Contract #: 04-0120F4Cty: SF/ALA Rte: 80 PM: 13.2/13.9File #: 69.28**WELDING INSPECTION REPORT****Resident Engineer:**Pursell, Gary**Address:** 333 Burma Road**City:** Oakland, CA 94607**Report No:** WIR-006949**Date Inspected:** 28-May-2009**Project Name:** SAS Superstructure**OSM Arrival Time:** 700**Prime Contractor:** American Bridge/Fluor Enterprises, a JV**OSM Departure Time:** 1900**Contractor:** Zhenhua Port Machinery Company, Ltd (ZPMC), Changxing Island **Location:** Shanghai, China**CWI Name:** Chen Chih Chien**CWI Present:** Yes No**Inspected CWI report:** Yes No N/A**Rod Oven in Use:** Yes No N/A**Electrode to specification:** Yes No N/A**Weld Procedures Followed:** Yes No N/A**Qualified Welders:** Yes No N/A**Verified Joint Fit-up:** Yes No N/A**Approved Drawings:** Yes No N/A**Approved WPS:** Yes No N/A**Delayed / Cancelled:** Yes No N/A**Bridge No:** 34-0006**Component:** OBG crossbeams**Summary of Items Observed:**

OBG cross beam CB1(in superstructure trial assembly)

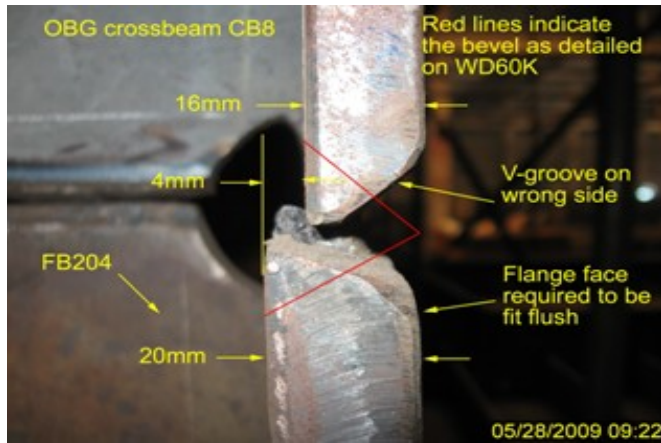
During random joint fit up inspection this QA observed two floorbeam diaphragm Complete Joint Penetration (CJP) weld joints that appeared to be misaligned beyond the tolerances of AWS D1.5 2002 section 3.3.3 which states parts to be joined by groove welds shall not be misaligned by more than 10% of the thickness of the thinner part or a maximum of 3mm. The joints in question appeared to be misaligned 5mm and 6mm. See attached photo

for details. The weld joints are identified as FB204-070 (2nd floorbeam from the north end) and FB205-032 (2nd floorbeam from the north end). This QA also observed two excessive root openings. One of the joints is a fillet weld joint identified as CB202G-155 and 156 (4th floorbeam from the north end). The root opening measured from 6mm to 10mm. The other joint is a CJP identified as FB205-029 (1st floorbeam from the north end). The root opening measured 10mm to 11mm. This QA informed ZPMC QC CWI identified as Mr. Chen Chih Chien and ABF QA inspector identified as Mr. Peng Wen Jun of these issues. Mr. Chen and Mr. Peng informed this QA that the misaligned joints would be corrected prior to welding, the excessive root opening on the CJP would be buttered (build up by welding) prior to welding the joint and the excessive fillet weld root opening would be changed to a CJP weld per approved submittal# 200, Rev. 2 dated Feb. 12, 2009. The proposed resolutions to these misalignment and root opening issues appear to be within the general scope of the contract documents and no incident report will be generated provided the contractor follows through with the proposed resolutions as outlined above.
